**FINAL ENVIRONMENTAL IMPACT STATEMENT**

**ELK HILLS/SOHIO PIPELINE CONNECTION  
CONVEYANCE SYSTEM**

**VOLUME II  
COMMENTS AND RESPONSES**

16 September 1977

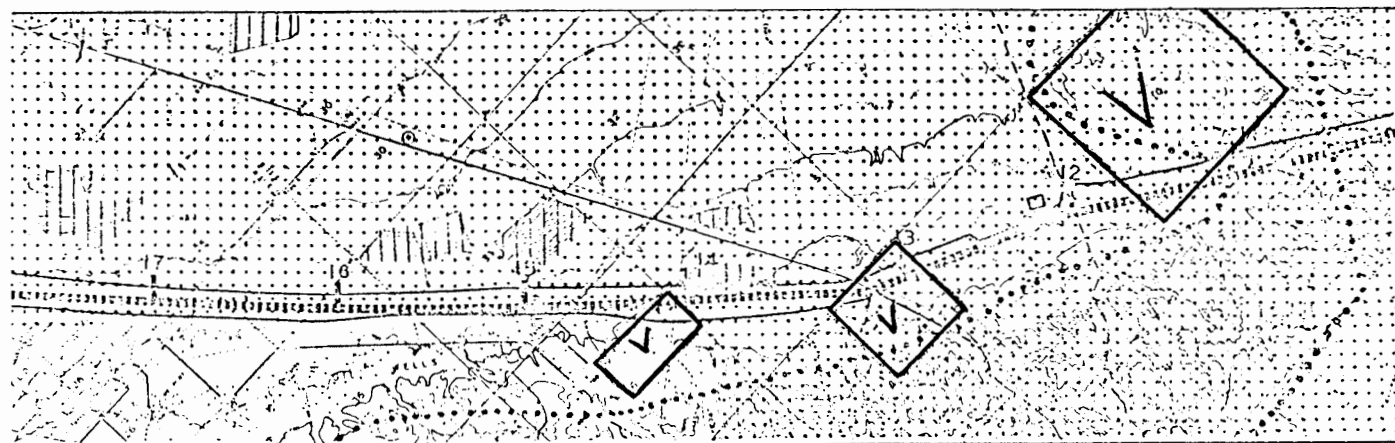
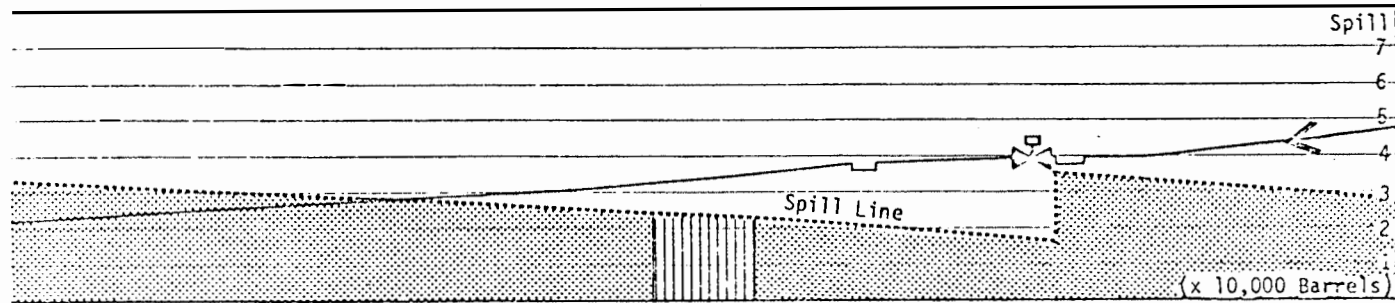
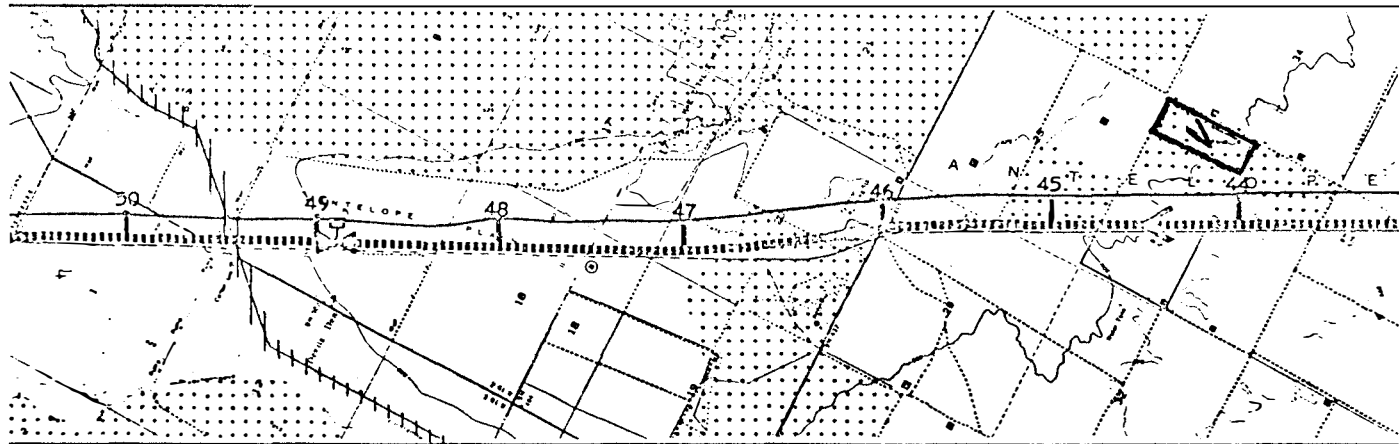
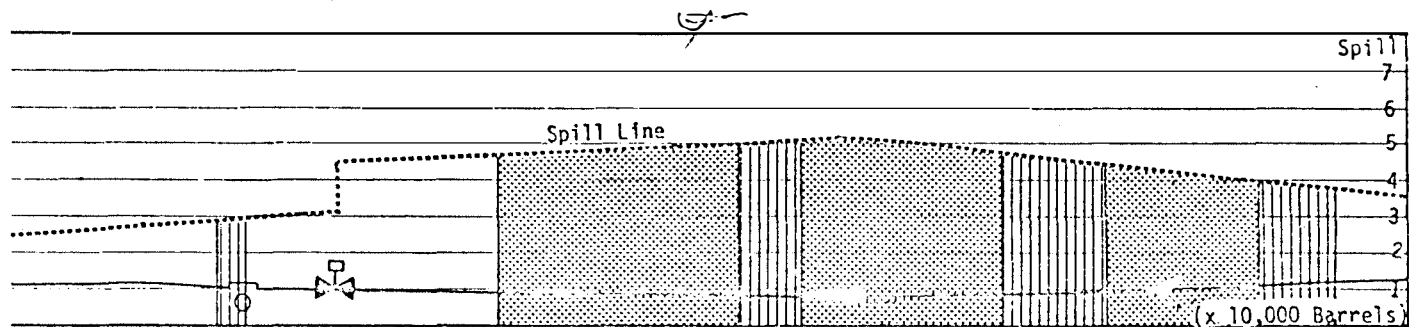
- C-2 The proposed pipeline route in T. 31 S., R. 22 E., Section 20 N 1/2 would directly impact blunt-nosed leopard lizard habitat. During the week of May 23, three blunt-nosed leopard lizards were sighted on this 320-acre parcel of public land. k
- 4-18 Follow through with suggestion in regard to protecting seedling oak trees that would be planted in place of destroyed oak trees along the pipeline. l.
- Explore the possibilities of chaparral seed mixes for pipeline construction in the chaparral zones - no recommendations. m

Water barring may be a possibility in the chaparral zone to prevent erosion (addressing the anticipated problems).

- 4-19 The destruction of creosote is probably a trade-off. It should be avoided as much as reasonably possible.

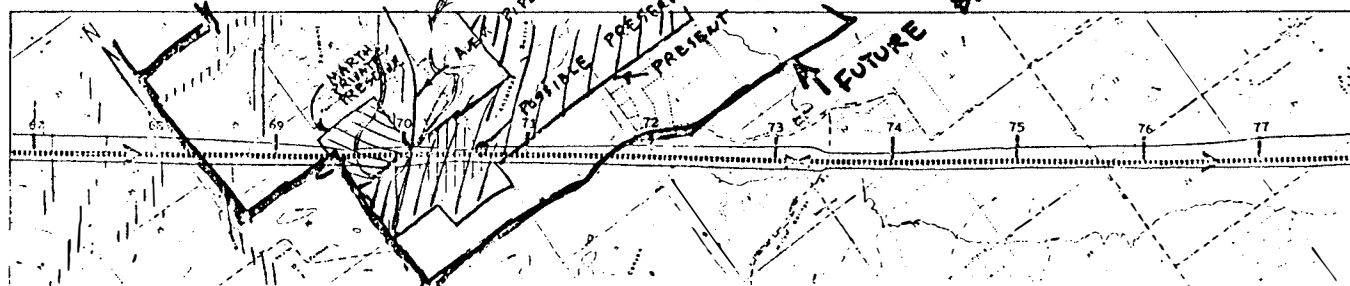
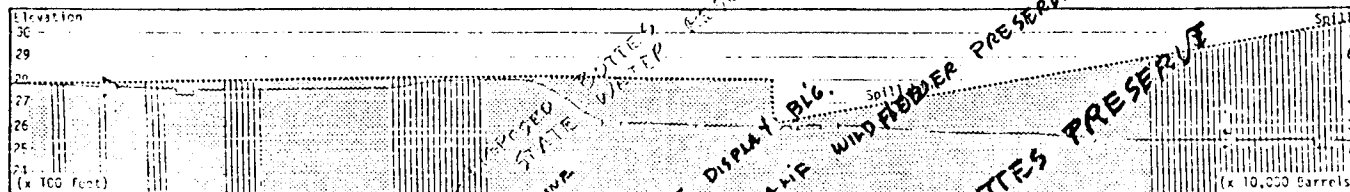
G-8 enclosed is corrected for major omissions covered above. Also missing are the above-ground impact of pumping stations, valves, etc in a sensitive desert-farming-living area.

I urge that if the line were routed in the Antelope Valley, it not go within 2 miles of the Antelope-Fairmont Buttes area, and that rather than being built on a
